- Request - Major Site Plan Review for Site Modifications
- Location - 313 Morris Street
- Applicant / Developer - Riverfront Ventures LLC  
122 S. Wilson Street Drawer D  
Fremont, OH 43420
- Architect - Architects Forum Midwest, LLC  
3232 Central Park West  
Toledo, OH 43617

The staff recommends that the Toledo City Plan Commission **approve** SPR25-0022, a Major Site Plan Review for Site Modifications at 313 Morris Street for the following **two (2) reasons**:

MAJOR SITE PLAN  
TOLEDO CITY PLAN COMMISSION  
REF: SPR25-0022  
DATE: July 3, 2025  
TIME: 2:00 P.M.

ARCHITECTURAL SITE PLAN  
SCALE: 1" = 30'-0"

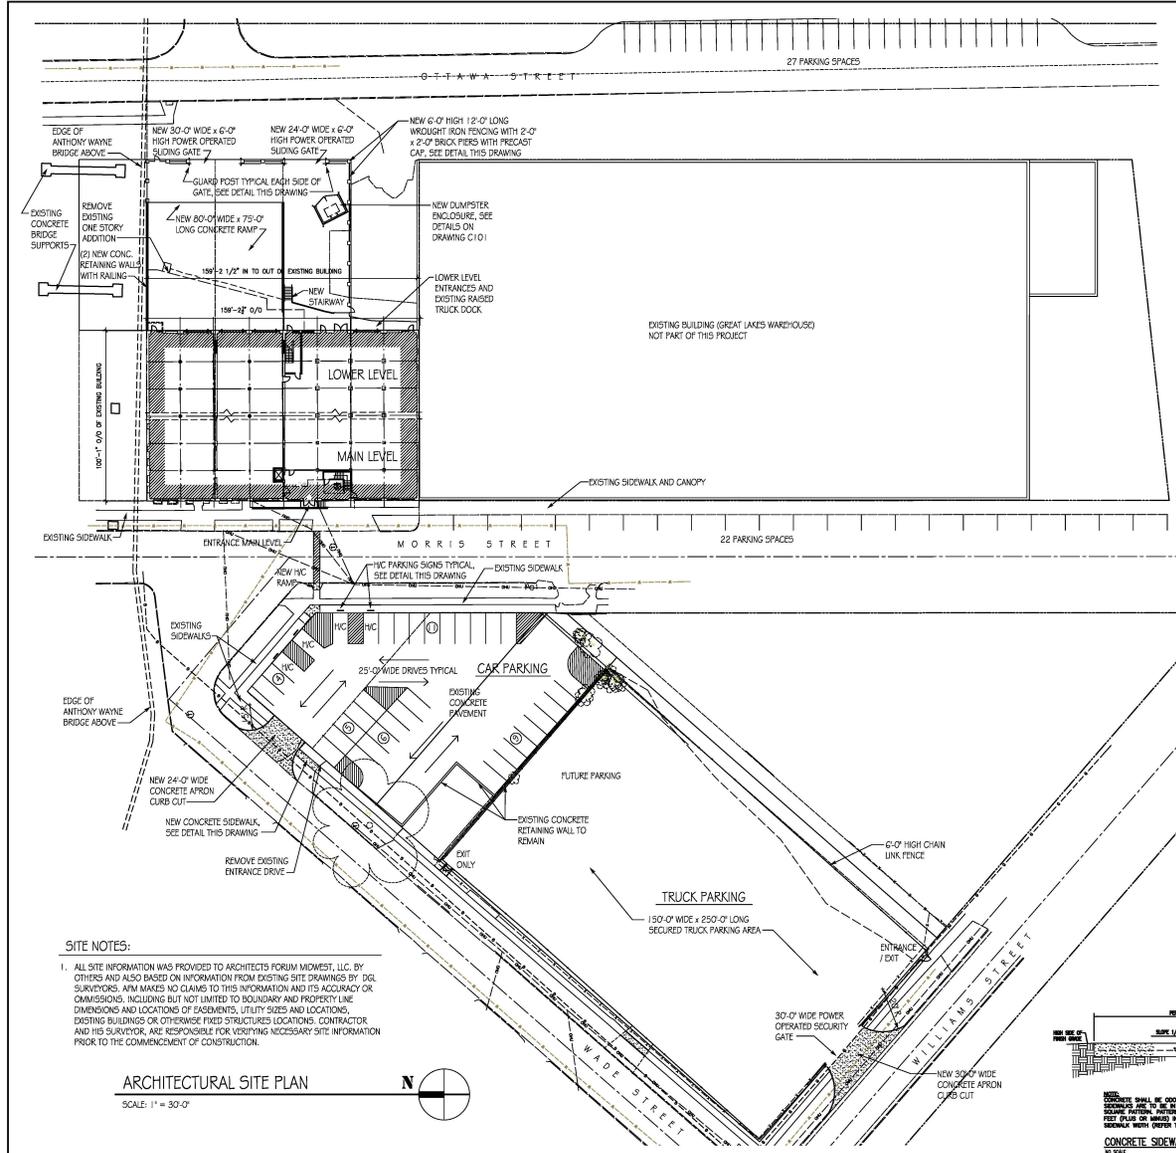
Per the Off-Street Parking Schedule C in TMC§1107.0304, office uses are required to provide one (1) parking space per 300 square feet of building area, requiring 159 parking spaces for the proposed development. There are thirty-five (35) parking spaces depicted on the site plan in parking lot on the west side of Morris Street and an additional six (6) spaces depicted on the floor plan for the lower level of the building. TMC§1107.0102(C) does allow for a reduction in the amount of off-street parking spaces required since the proposed use of the building is different than is once was; however, the required minimum parking is still not met. As such, an alternative access and parking plan shall be submitted to the Planning Director for review as a condition of approval. Staff is supportive of working with applicant to determine adequate parking needed for the development.

Accessible parking spaces are required to be provided based on the number of parking spaces required. The site plan depicts four (4) car accessible parking spaces. Since an alternative access and parking plan is required to determine the amount of off-street parking spaces required; accessible parking compliance cannot be determined at this time. The required number of accessible parking spaces shall be determined and provided based on the approved alternative access and parking plan as a condition of approval.

5. The site plan should be revised to include a proposal for stormwater management, proportional to the amount of new development. Pavement of existing stone surfaces along Morris is development greater than 2,500 square feet for which new stormwater management infrastructure is required on site. Stone surfaces which existed since 2004 do not require new stormwater management if approved for a gravel waiver by the Board of Zoning Appeals (BZA).
6. Earthwork greater than 2,500 square feet requires submittal and approval of a stormwater pollution prevention plan.
7. New structures shall not inhibit access to existing sewers in the area. Sanitary sewer not shown on drawing or picked up in survey.

32. Parking layout and surfacing information is not provided for the area noted as future truck parking. Should the area be required to be factored into stormwater management for the site, the site plan shall be revised to show the layout and proposed surface for the truck parking area. If not required at this time, the area shall be submitted for a Minor Site Plan review at such time it will be utilized for truck parking.

33. The proposed forty-one (41) off-street parking spaces do not meet the minimum 159 required off-street parking spaces in the Off-Street Parking Schedule C in TMC§1107.0304 for office uses; therefore an alternative access and parking plan shall be submitted to the Planning Director for review and approval. A revised site plan shall be submitted to the Planning Director depicting the required number of parking spaces based on the alternative access and parking plan.

34. Accessible parking spaces are required to be provided based on the number of parking spaces provided per TMC§1107.1701. The required number of accessible parking spaces shall be determined and provided based on the approved alternative access and parking plan. A revised site plan shall be submitted to the Planning Director depicting the accessible spaces.

LANDSCAPE PLAN

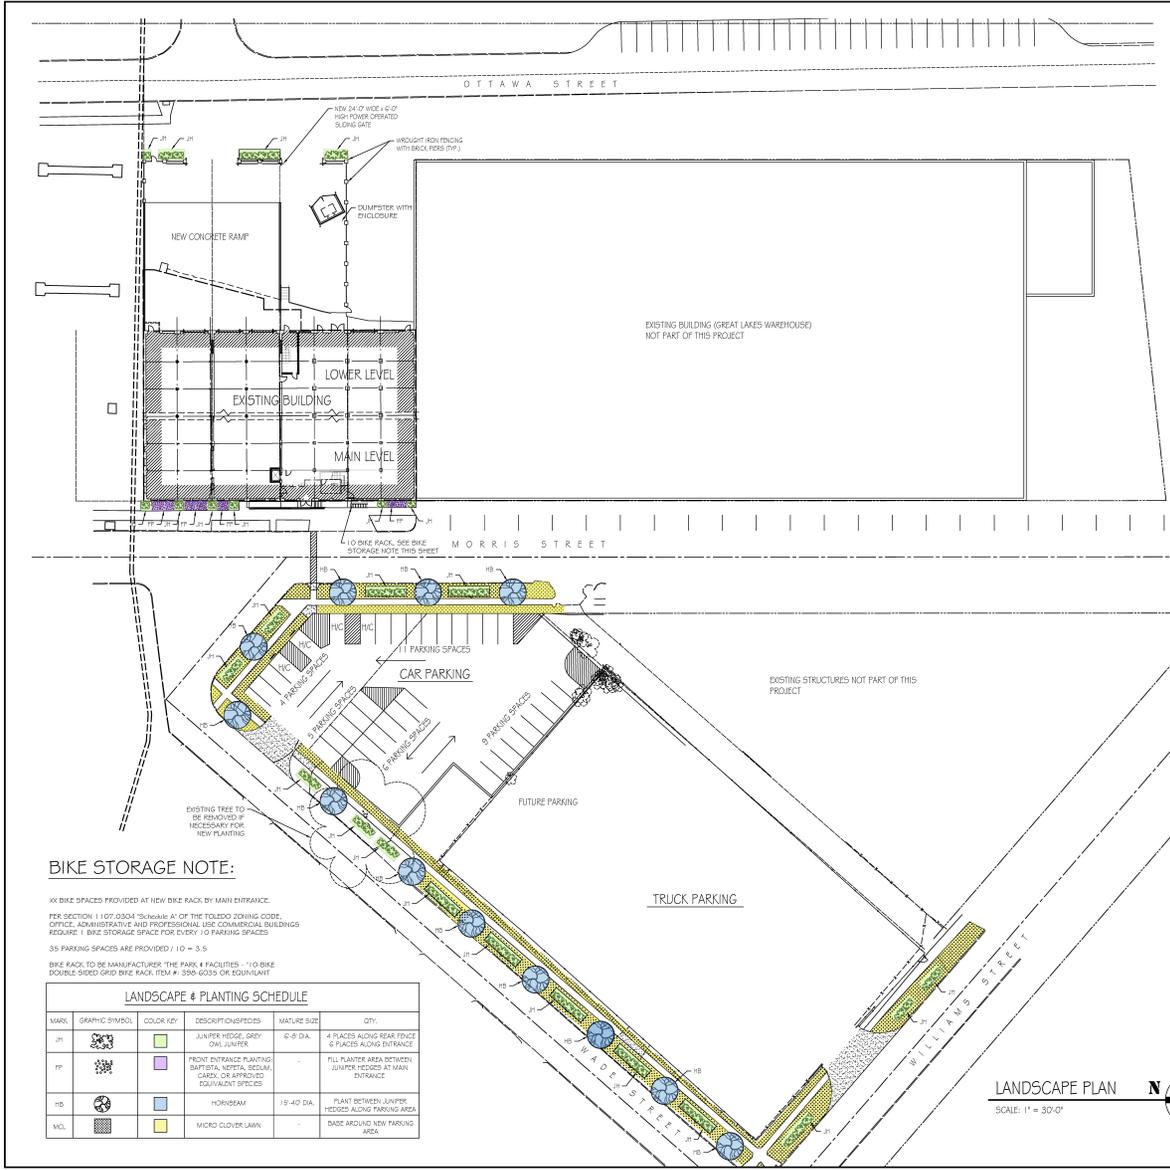
In addition to the minimum number of off-street parking and accessible parking spaces, bicycle parking slots are also required per the Off-Street Parking Schedule in TMC§1107.0304. One (1) bicycle parking slot is required per ten (10) parking spaces for office uses. Ten (10) bicycle parking slots are depicted on the landscape plan. While the landscape plan depicts a bicycle rack for ten (10) bicycles to the south of the main entrance, it is unclear how the rack will be accessed and if parked bicycles will encroach into the existing sidewalk. The required number of bicycle parking spaces shall

be determined and provided based on the approved alternative access and parking plan and additional information shall be submitted concerning the proposed bicycle rack as a condition of approval.

A six-foot (6') tall wrought iron fence with brick piers and landscaping in front is proposed along the Ottawa Street in the back of the property. As illustrated on the landscape plan it appears that the landscaping and possibly the fence is within the right-of-way. Since the property is across the street from the entrance to the Middlegrounds Metropark and directly across from the Middlegrounds Dog Park, it is important that this landscaping and screening not only be aesthetically pleasing but also visually shield any outdoor storage or outdoor use of the subject property. Additional information on the location and visibility shall be submitted to determine compliance with screening and setback requirements as a condition of approval.

35. One (1) bicycle parking slot shall be provided per ten (10) parking spaces pursuant to Off-Street Parking Schedule “A,” (TMC§1107.0300) for office uses. Ten (10) bicycle parking slots are depicted on the landscape plan south of the main entrance. The required number of bicycle parking spaces shall be determined and provided based on the approved alternative access and parking plan and additional information shall be submitted concerning the proposed bicycle rack to determine possible conflict with the adjacent sidewalk.

- b. As illustrated on the landscape plan, it appears that the six-foot (6’) tall wrought iron fence with brick piers and landscaping in front proposed along the Ottawa Street is within the right-of-way. Additional information on the location and outdoor storage or outdoor use of the subject property in the back of the building shall be submitted to determine compliance with screening and setback requirements.

# NORTH & WEST ELEVATIONS

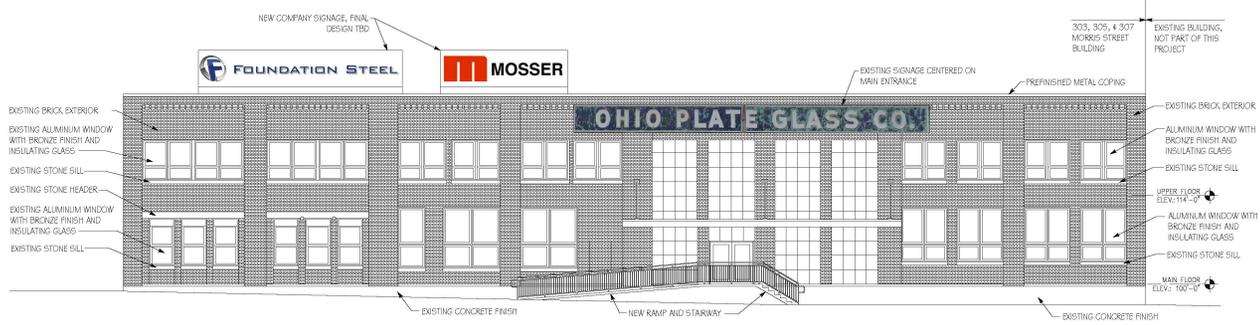
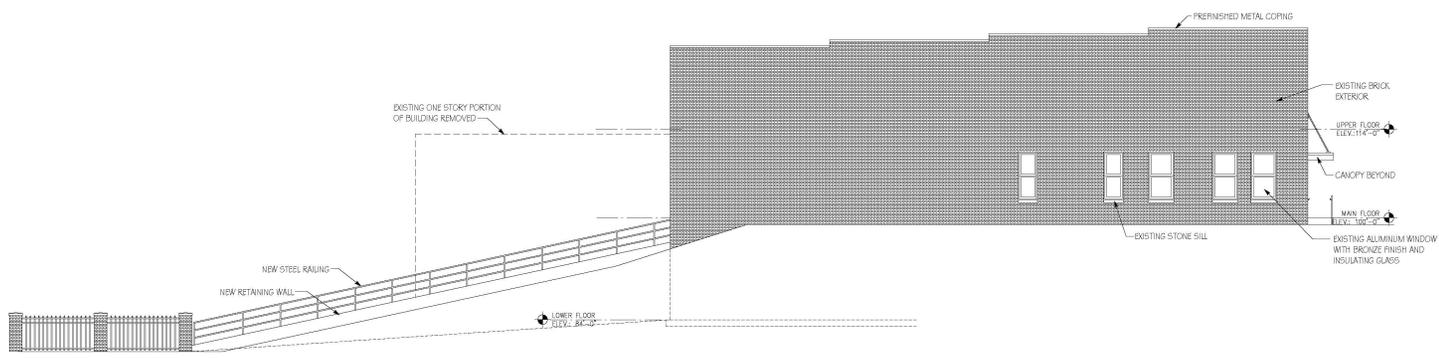
The submitted elevations depict signs above the roofline on the existing building with a notation that the final design is to be determined. Building signs may not extend above the height of the building per TMC§1108.0304(B). The location of the depicted signs are therefore not permitted. All proposed signage must meet the regulations in Chapter 1113 - Signs. Additionally, a sign permit shall be obtained for any proposed signage on site. These are listed as conditions of approval.

- h. The location, lighting, and size of any signs.
  - i. Landscaping shall be installed and maintained indefinitely.
37. All proposed signage for the site shall be meet the requirements of TMC§1113.000. A sign permit shall be submitted and approved for all signage.
